Access Compliance Report

Public Rights-of-Way

Intersection ID: 3945	Main Street: ARMITAGE_DR	Cross Street: LIBERTY_BELL_CT	Location: NW
ADA ID: 2FA9472C4708	Ramp Type: BlendTrans1	Initial Pass/Fail: Fail	Overall Compliance: No
		Severity Score: 30

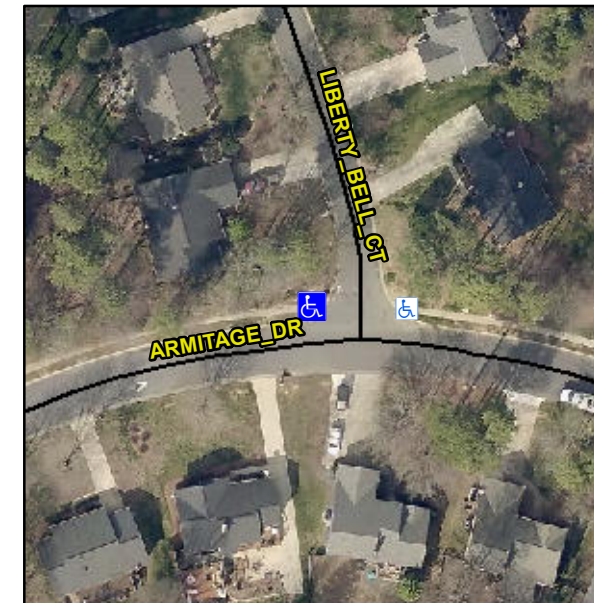
Not Found, R304.5.1, R304.5.3

Compliance	Description	Data	Compliance	Description	Data
N/A	Ramp Length (in)	82.0	Yes	BlendTrans Slope (%)	3.7
No	Ramp Width (in)	32.0	No	BlendTrans XSlope (%)	6.9
N/A	Flare Type LT	N/A	N/A	Flare Type RT	N/A
N/A	Flare Slope LT (%)	N/A	N/A	Flare Slope RT (%)	N/A
N/A	Flare Traversable LT?	N/A	N/A	Flare Traversable RT?	N/A
N/A	Landing Length (in)	N/A	N/A	DWS Provided?	N/A
N/A	Landing Width (in)	N/A	N/A	DWS Contrast?	N/A
N/A	Landing Slope (%)	N/A	N/A	DWS Length (in)	N/A
N/A	Landing X Slope (%)	N/A	N/A	DWS Full Width?	N/A
N/A	Landing Curb? (Y/N)	N/A	N/A	DWS Offset (in)	N/A
N/A	Shared Landing?	N/A			
N/A	Gutter Ponding?	N/A	N/A	Gutter Slope (%)	N/A
N/A	Gutter Lip Ht (in)	N/A	N/A	Gutter X Slope (%)	N/A
N/A	Painted X Walk1?	No	N/A	Painted X Walk2?	N/A
	X Walk 1 Direction	To E		X Walk 2 Direction	N/A
	X Walk 1 Width (in)	N/A		X Walk 2 Width (in)	N/A
	X Walk 1 Slope (%)	5.8		X Walk 2 Slope (%)	N/A
	X Walk 1 X Slope (%)	4.3		X Walk 2 X Slope (%)	N/A

N/A	Ramp inside XWalk1?	N/A	N/A	Ramp inside XWalk2?	N/A
	Road Slope (%)	4.3		Clear Space?	N/A
	Road X Slope (%)	5.8	N/A	Clear Space to XWalk (in)	N/A
N/A	Any Obstructions?	N/A	N/A	Storm Grate/Utility Hazard?	N/A
	Obstruction Type			Storm Grate/Utility Type	
		N/A			N/A
			Yes	Surface Condition? (G/P)	Good
			No	Curb Slope (%)	11.5

Remove & Replace Curb Ramp With Two New Directional Ramps or Equivalent.
